# TECHNICAL BULLETIN

## Front Brake Rattle – Disc Shield – Install New Retaining Screws

70-25

MODEL Sedan Range 1994 - 95 MY  
VIN 674930 - 756474

ILLUSTRATION 1

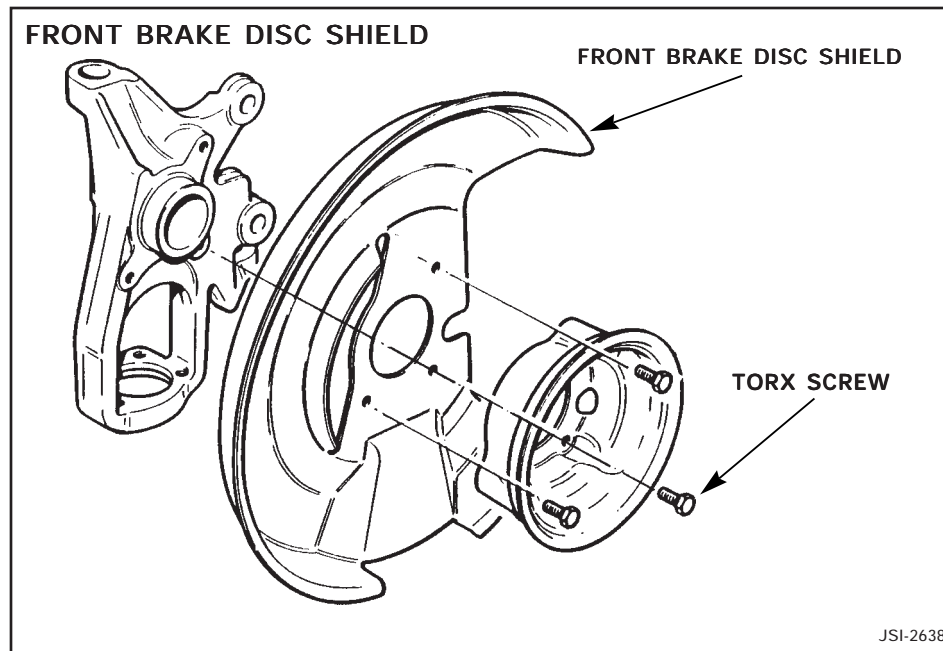
Some 1994 - 95 MY Sedan Range vehicles within the above VIN range may experience a noise from the front brake area.

The noise is caused by loosening of the Torx screws that secure the brake disc shield and the water shield to the stub axle, allowing the shields to vibrate.

In case of a customer complaint remove the hub assembly as described in Section 70.10.18 of the XJ6 - XJ12 Saloon Range Service Manual. Remove and discard the old screws. Install the new screws listed in the Parts Information and torque to 7.4 - 8.8 lb. ft. (10 -12 Nm.)

**NOTE:** When the hub is removed, the seal must be replaced with a new one using Special Tool JD 179. The seal face that contacts the hub must be coated with a special lubricant (Shell Retinex LC). Thoroughly clean all traces of the previous lubricant from the hub.
